WILLMORE ELEMENTARY SCHOOL

WESTMINSTER SCHOOL DISTRICT

WESTMINSTER CALIFORNIA

FRAME TYPES SCALE: 1/4"=1'-0"

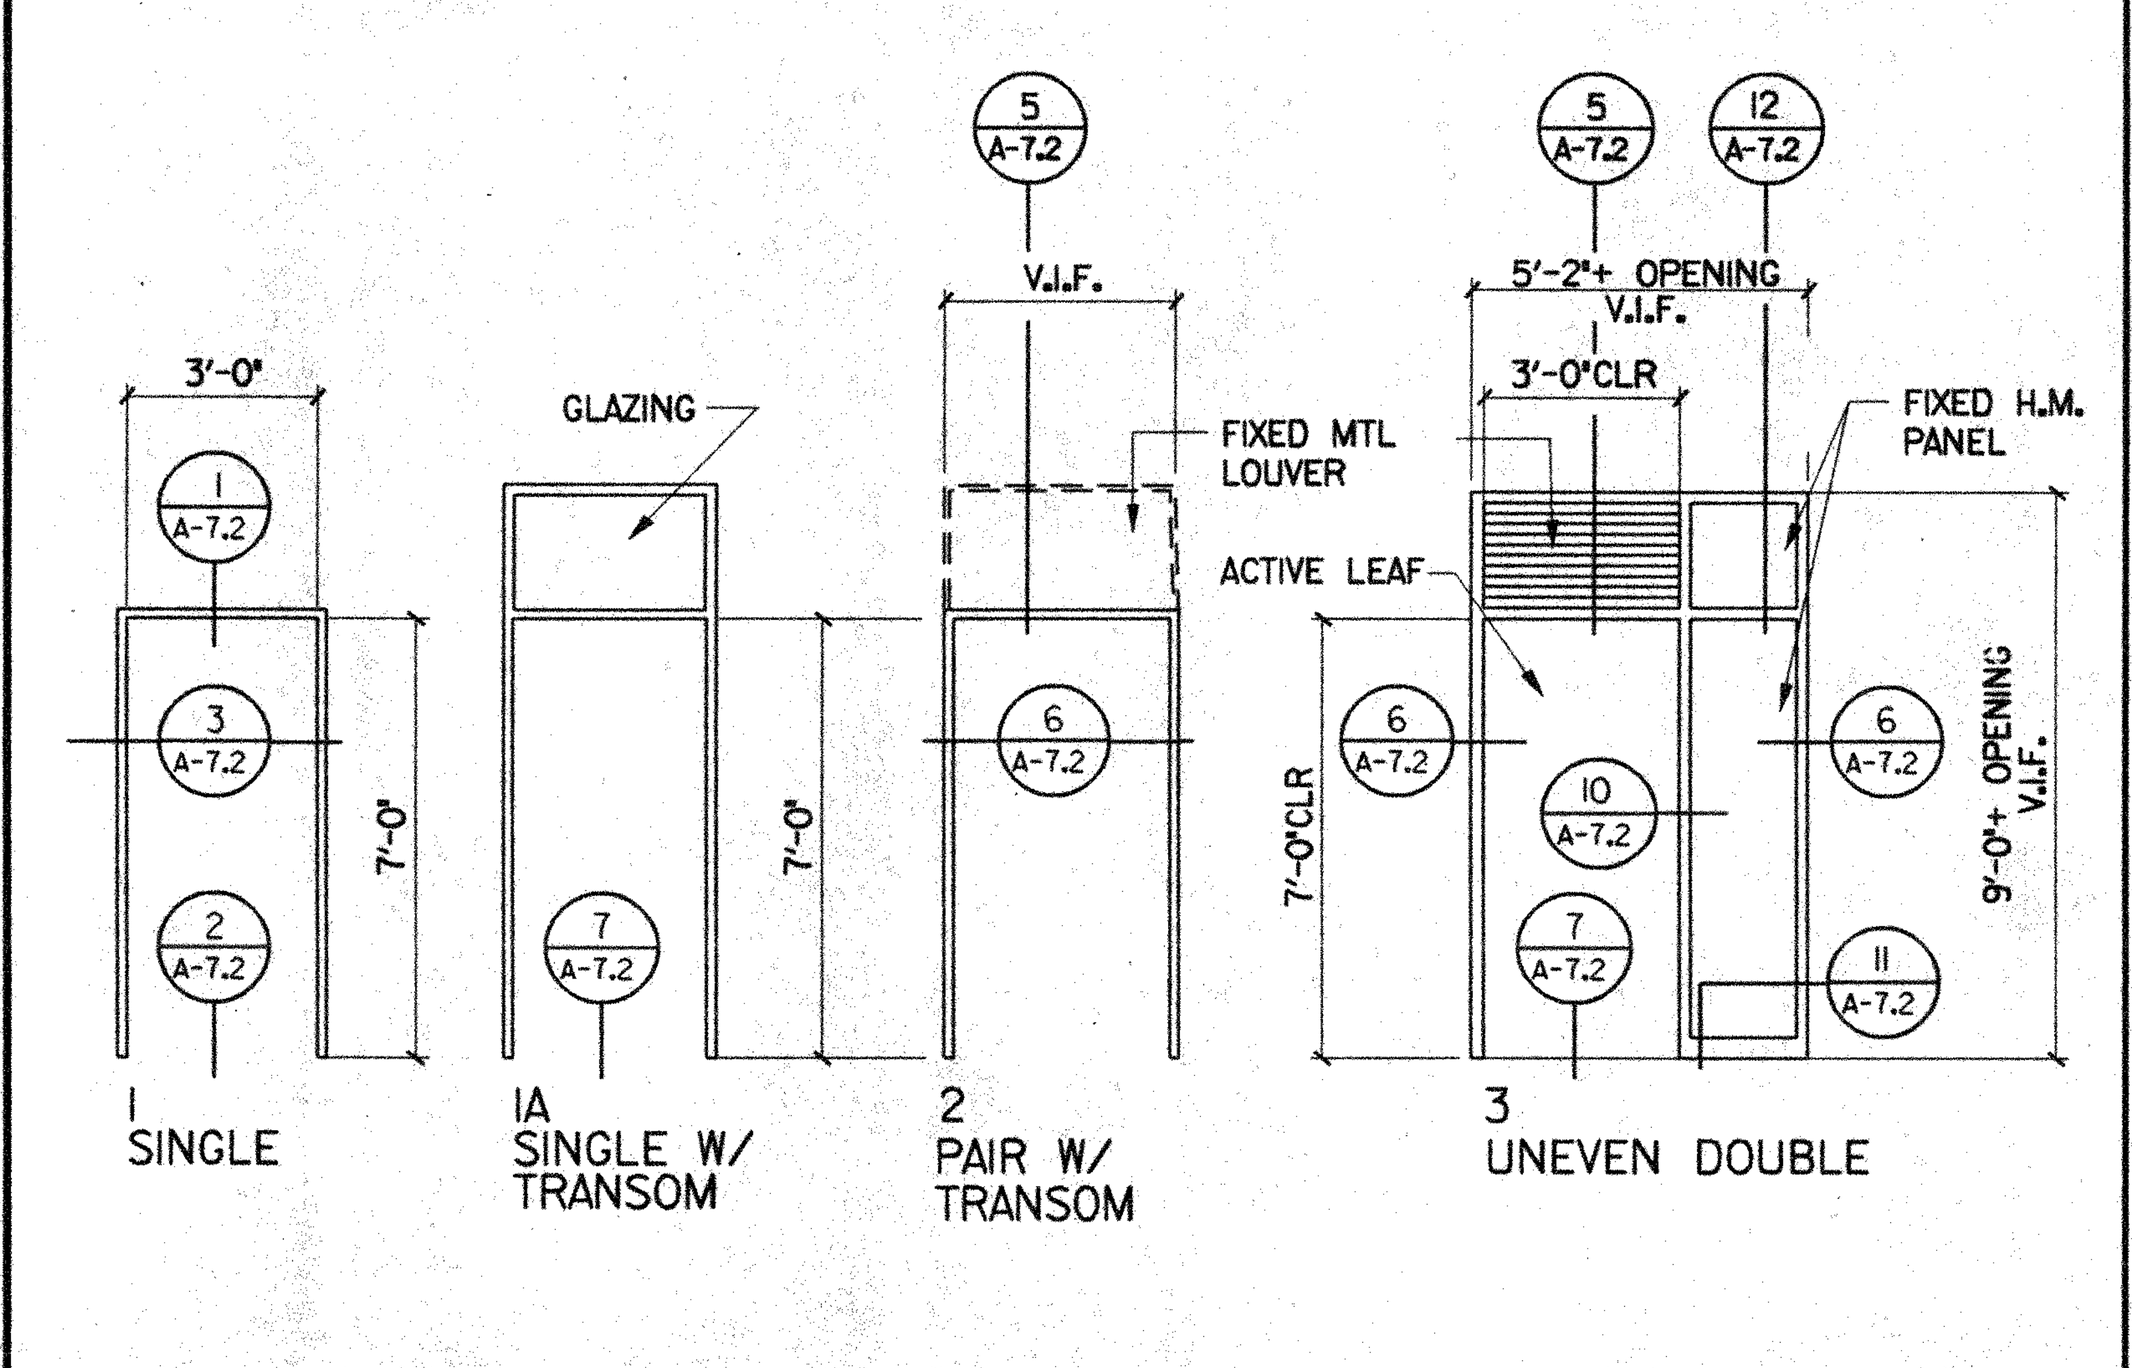
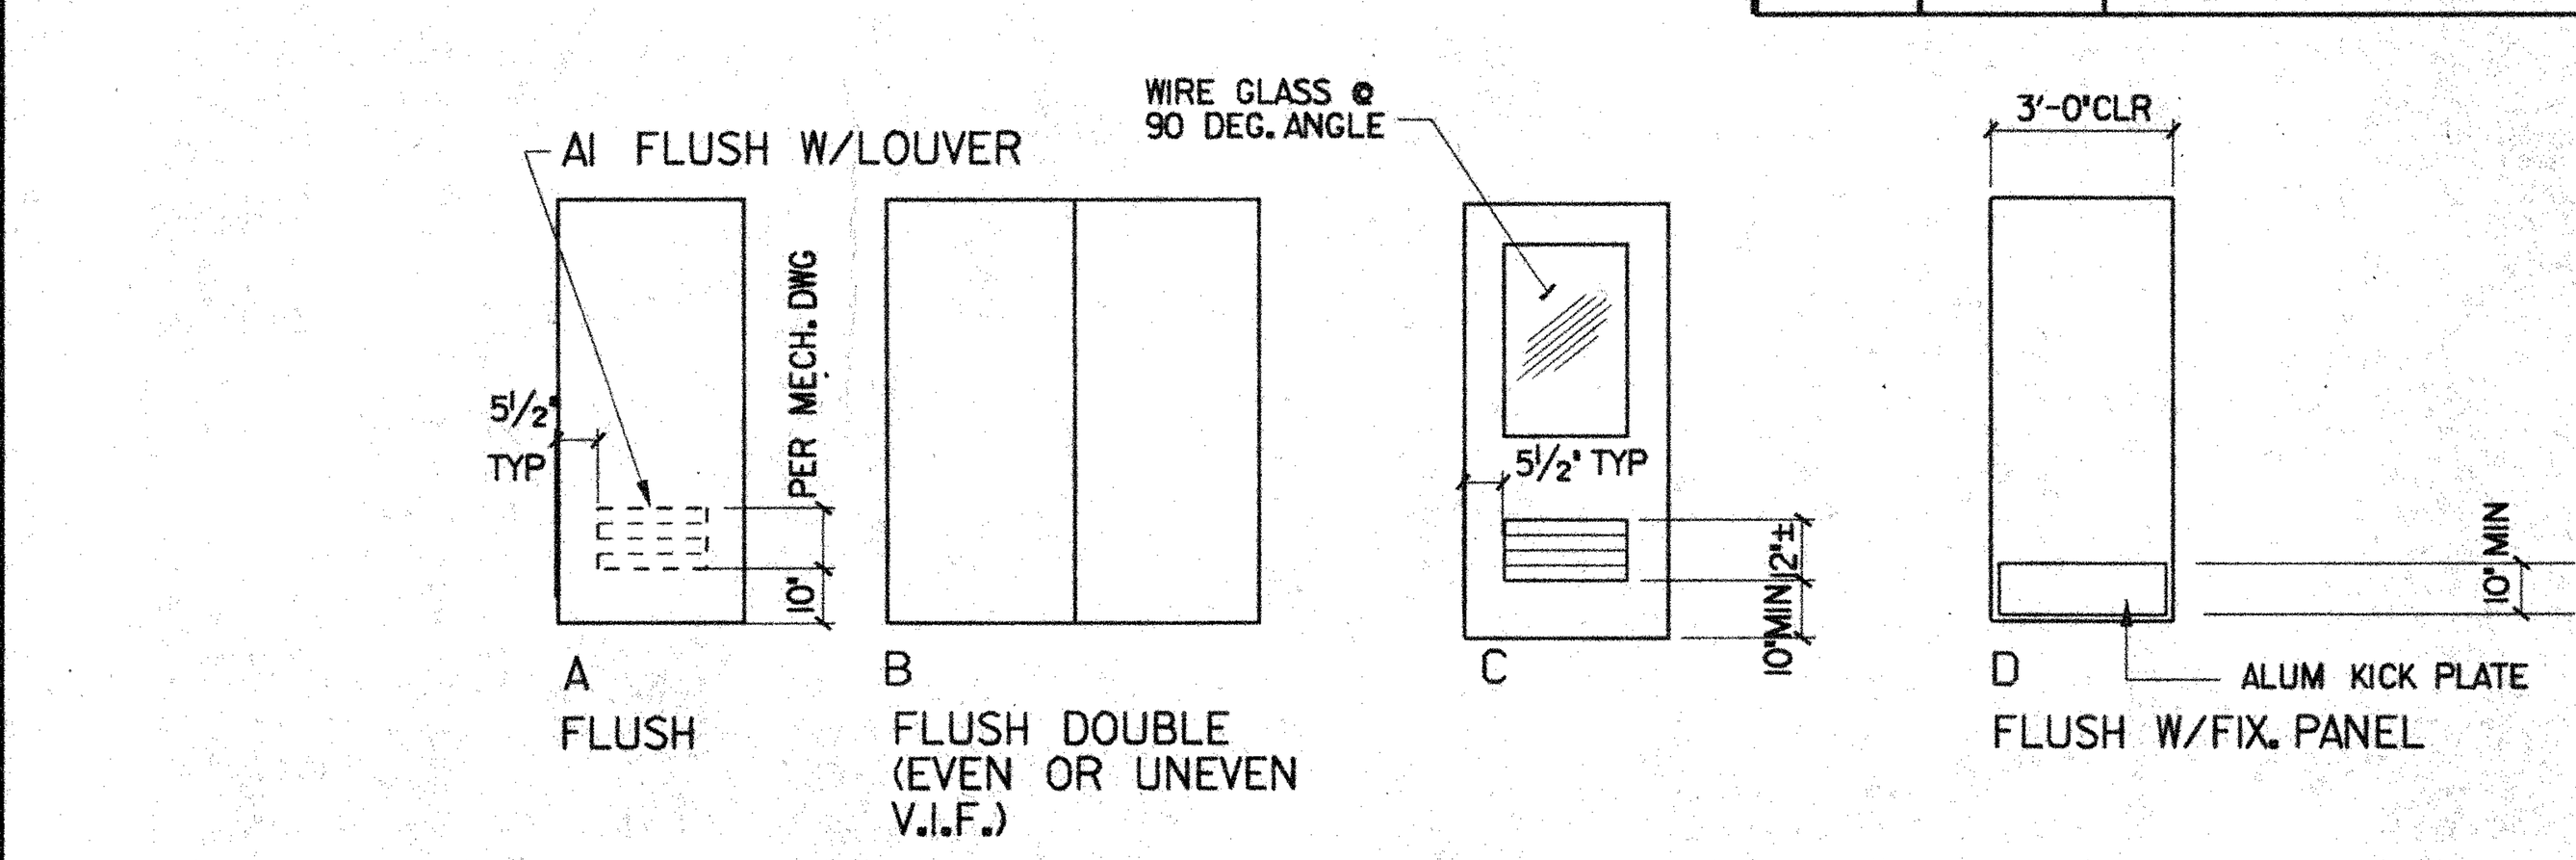
3.24 SHEET A-7.1 - DOOR, WINDOW, & FINISH SCHEDULES
32. At Door Schedule, At Doors 'B-5', 'C-5', 'C-10', and 'D-10', CHANGE from 'H.M.' to read "wood" and CHANGE 'metal' to read "solid core".

CLASSROOM BUILDING - "A - B" DEMOLITION PLAN

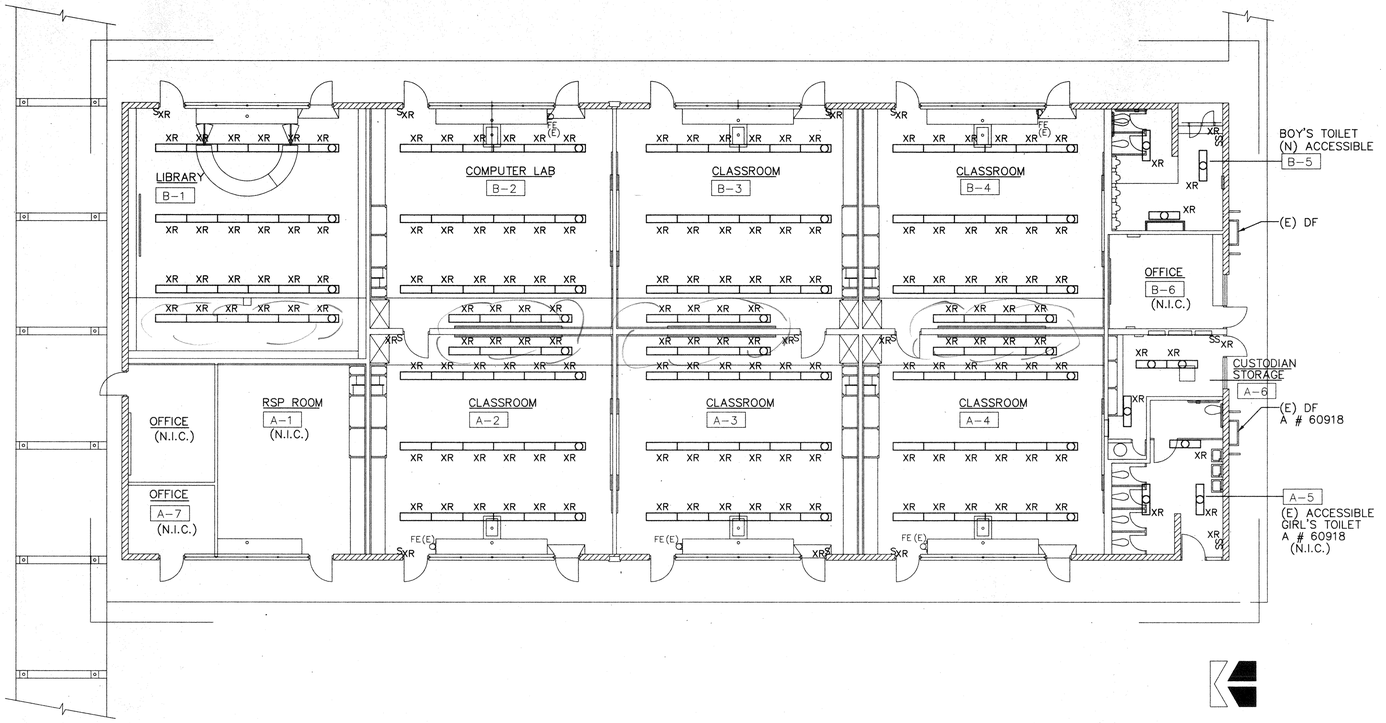
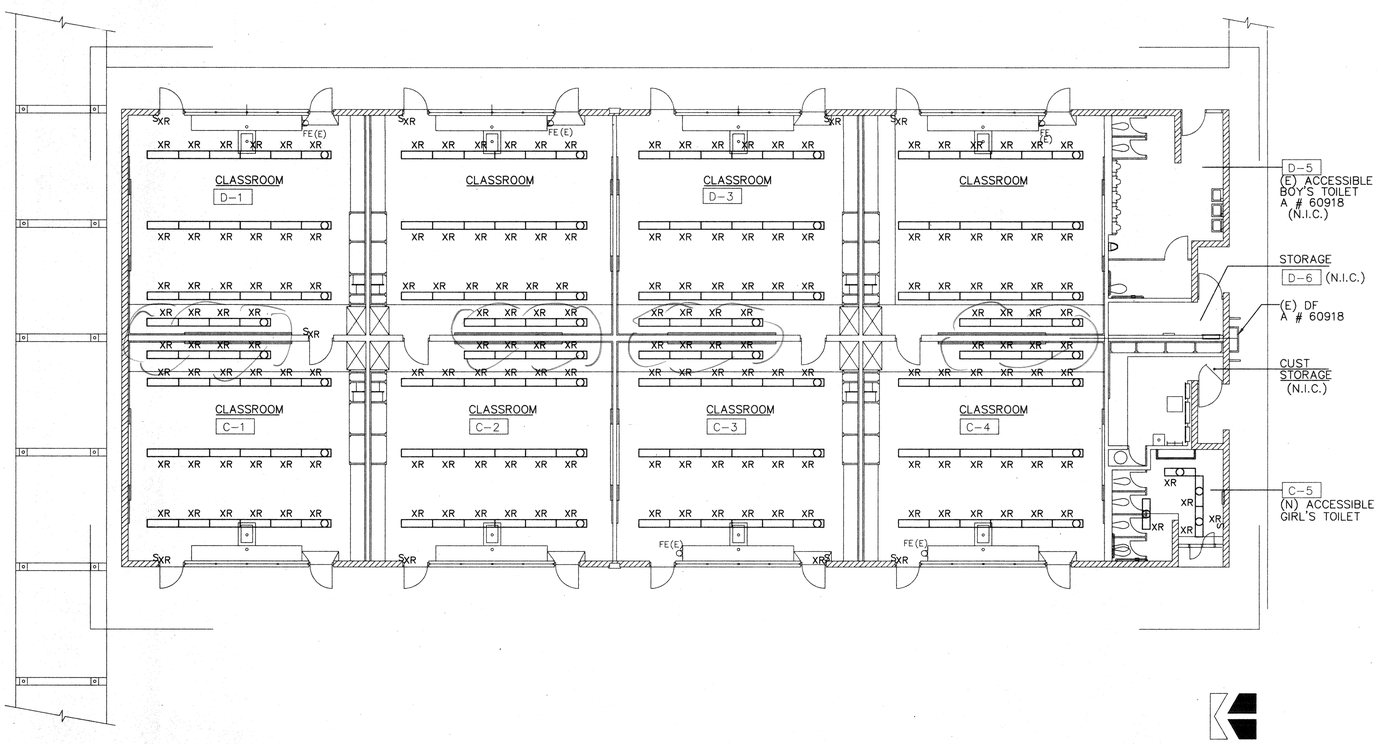
94. **ADDENDUM DRAWING AD1-3** is issued with this Addendum #1 to show partial drawing typical for all classrooms in Bldgs. 'A – B' and 'C – D'.
